# REPORT FOR INDEPENDENT INSPECTOR

## 66 Lawrence Avenue

### 1. Matter for Consideration

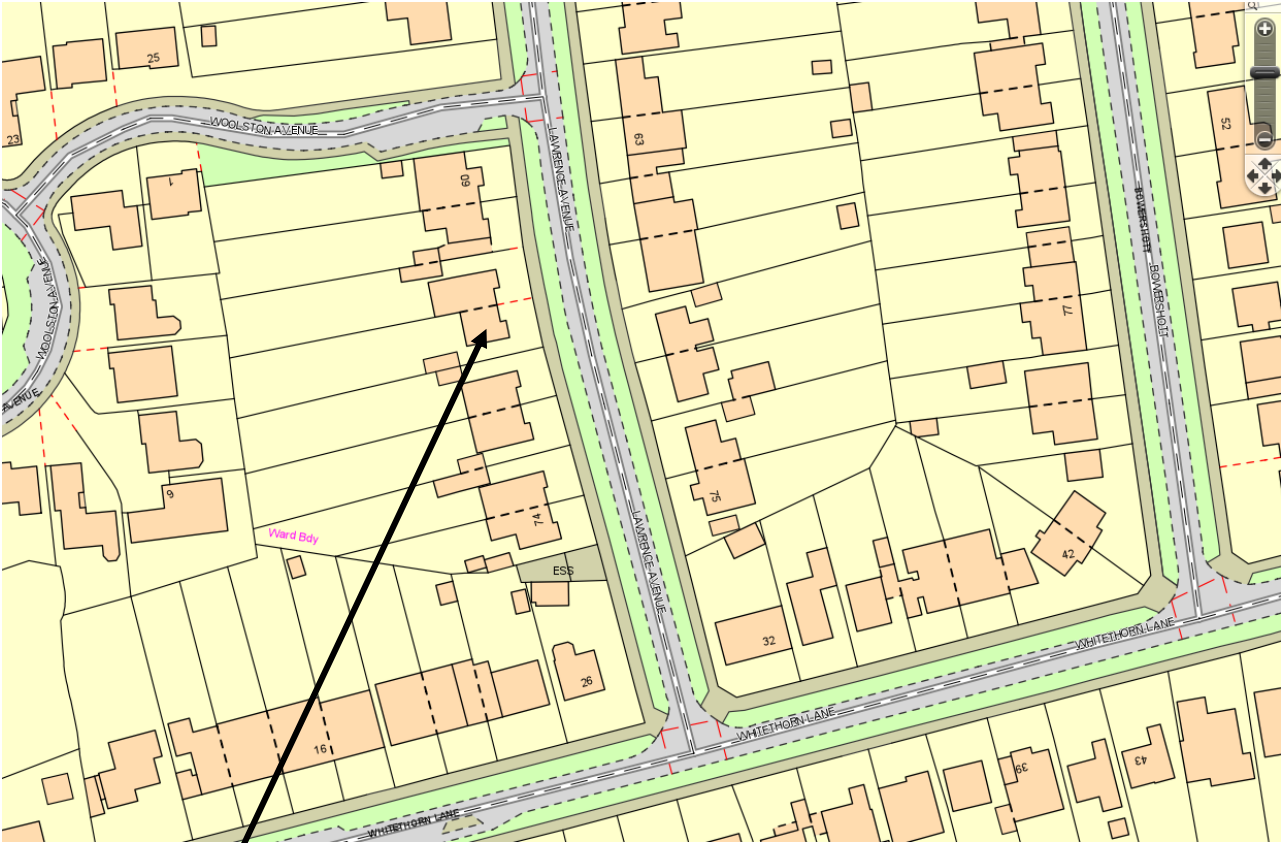
- 6.1 The Committee raised concerns with the rear fenestration and the rooflines.
- 6.2 The Committee noted that the ground floor proposal will be in line with the neighbouring extension.
- 6.3 The Committee felt that a flat roof parapet wrap-around extension would be more in keeping within the context of the streetscene.
- 6.4 The Committee felt that a lean-to porch may be acceptable.

- 6.5 The Committee felt that the frontage soft landscaping should be increased.
- 6.6 The Committee members were unanimous in supporting the decision to refuse consent, made by the Heritage Advice Service, but felt that negotiations could be initiated to agree an acceptable proposal.
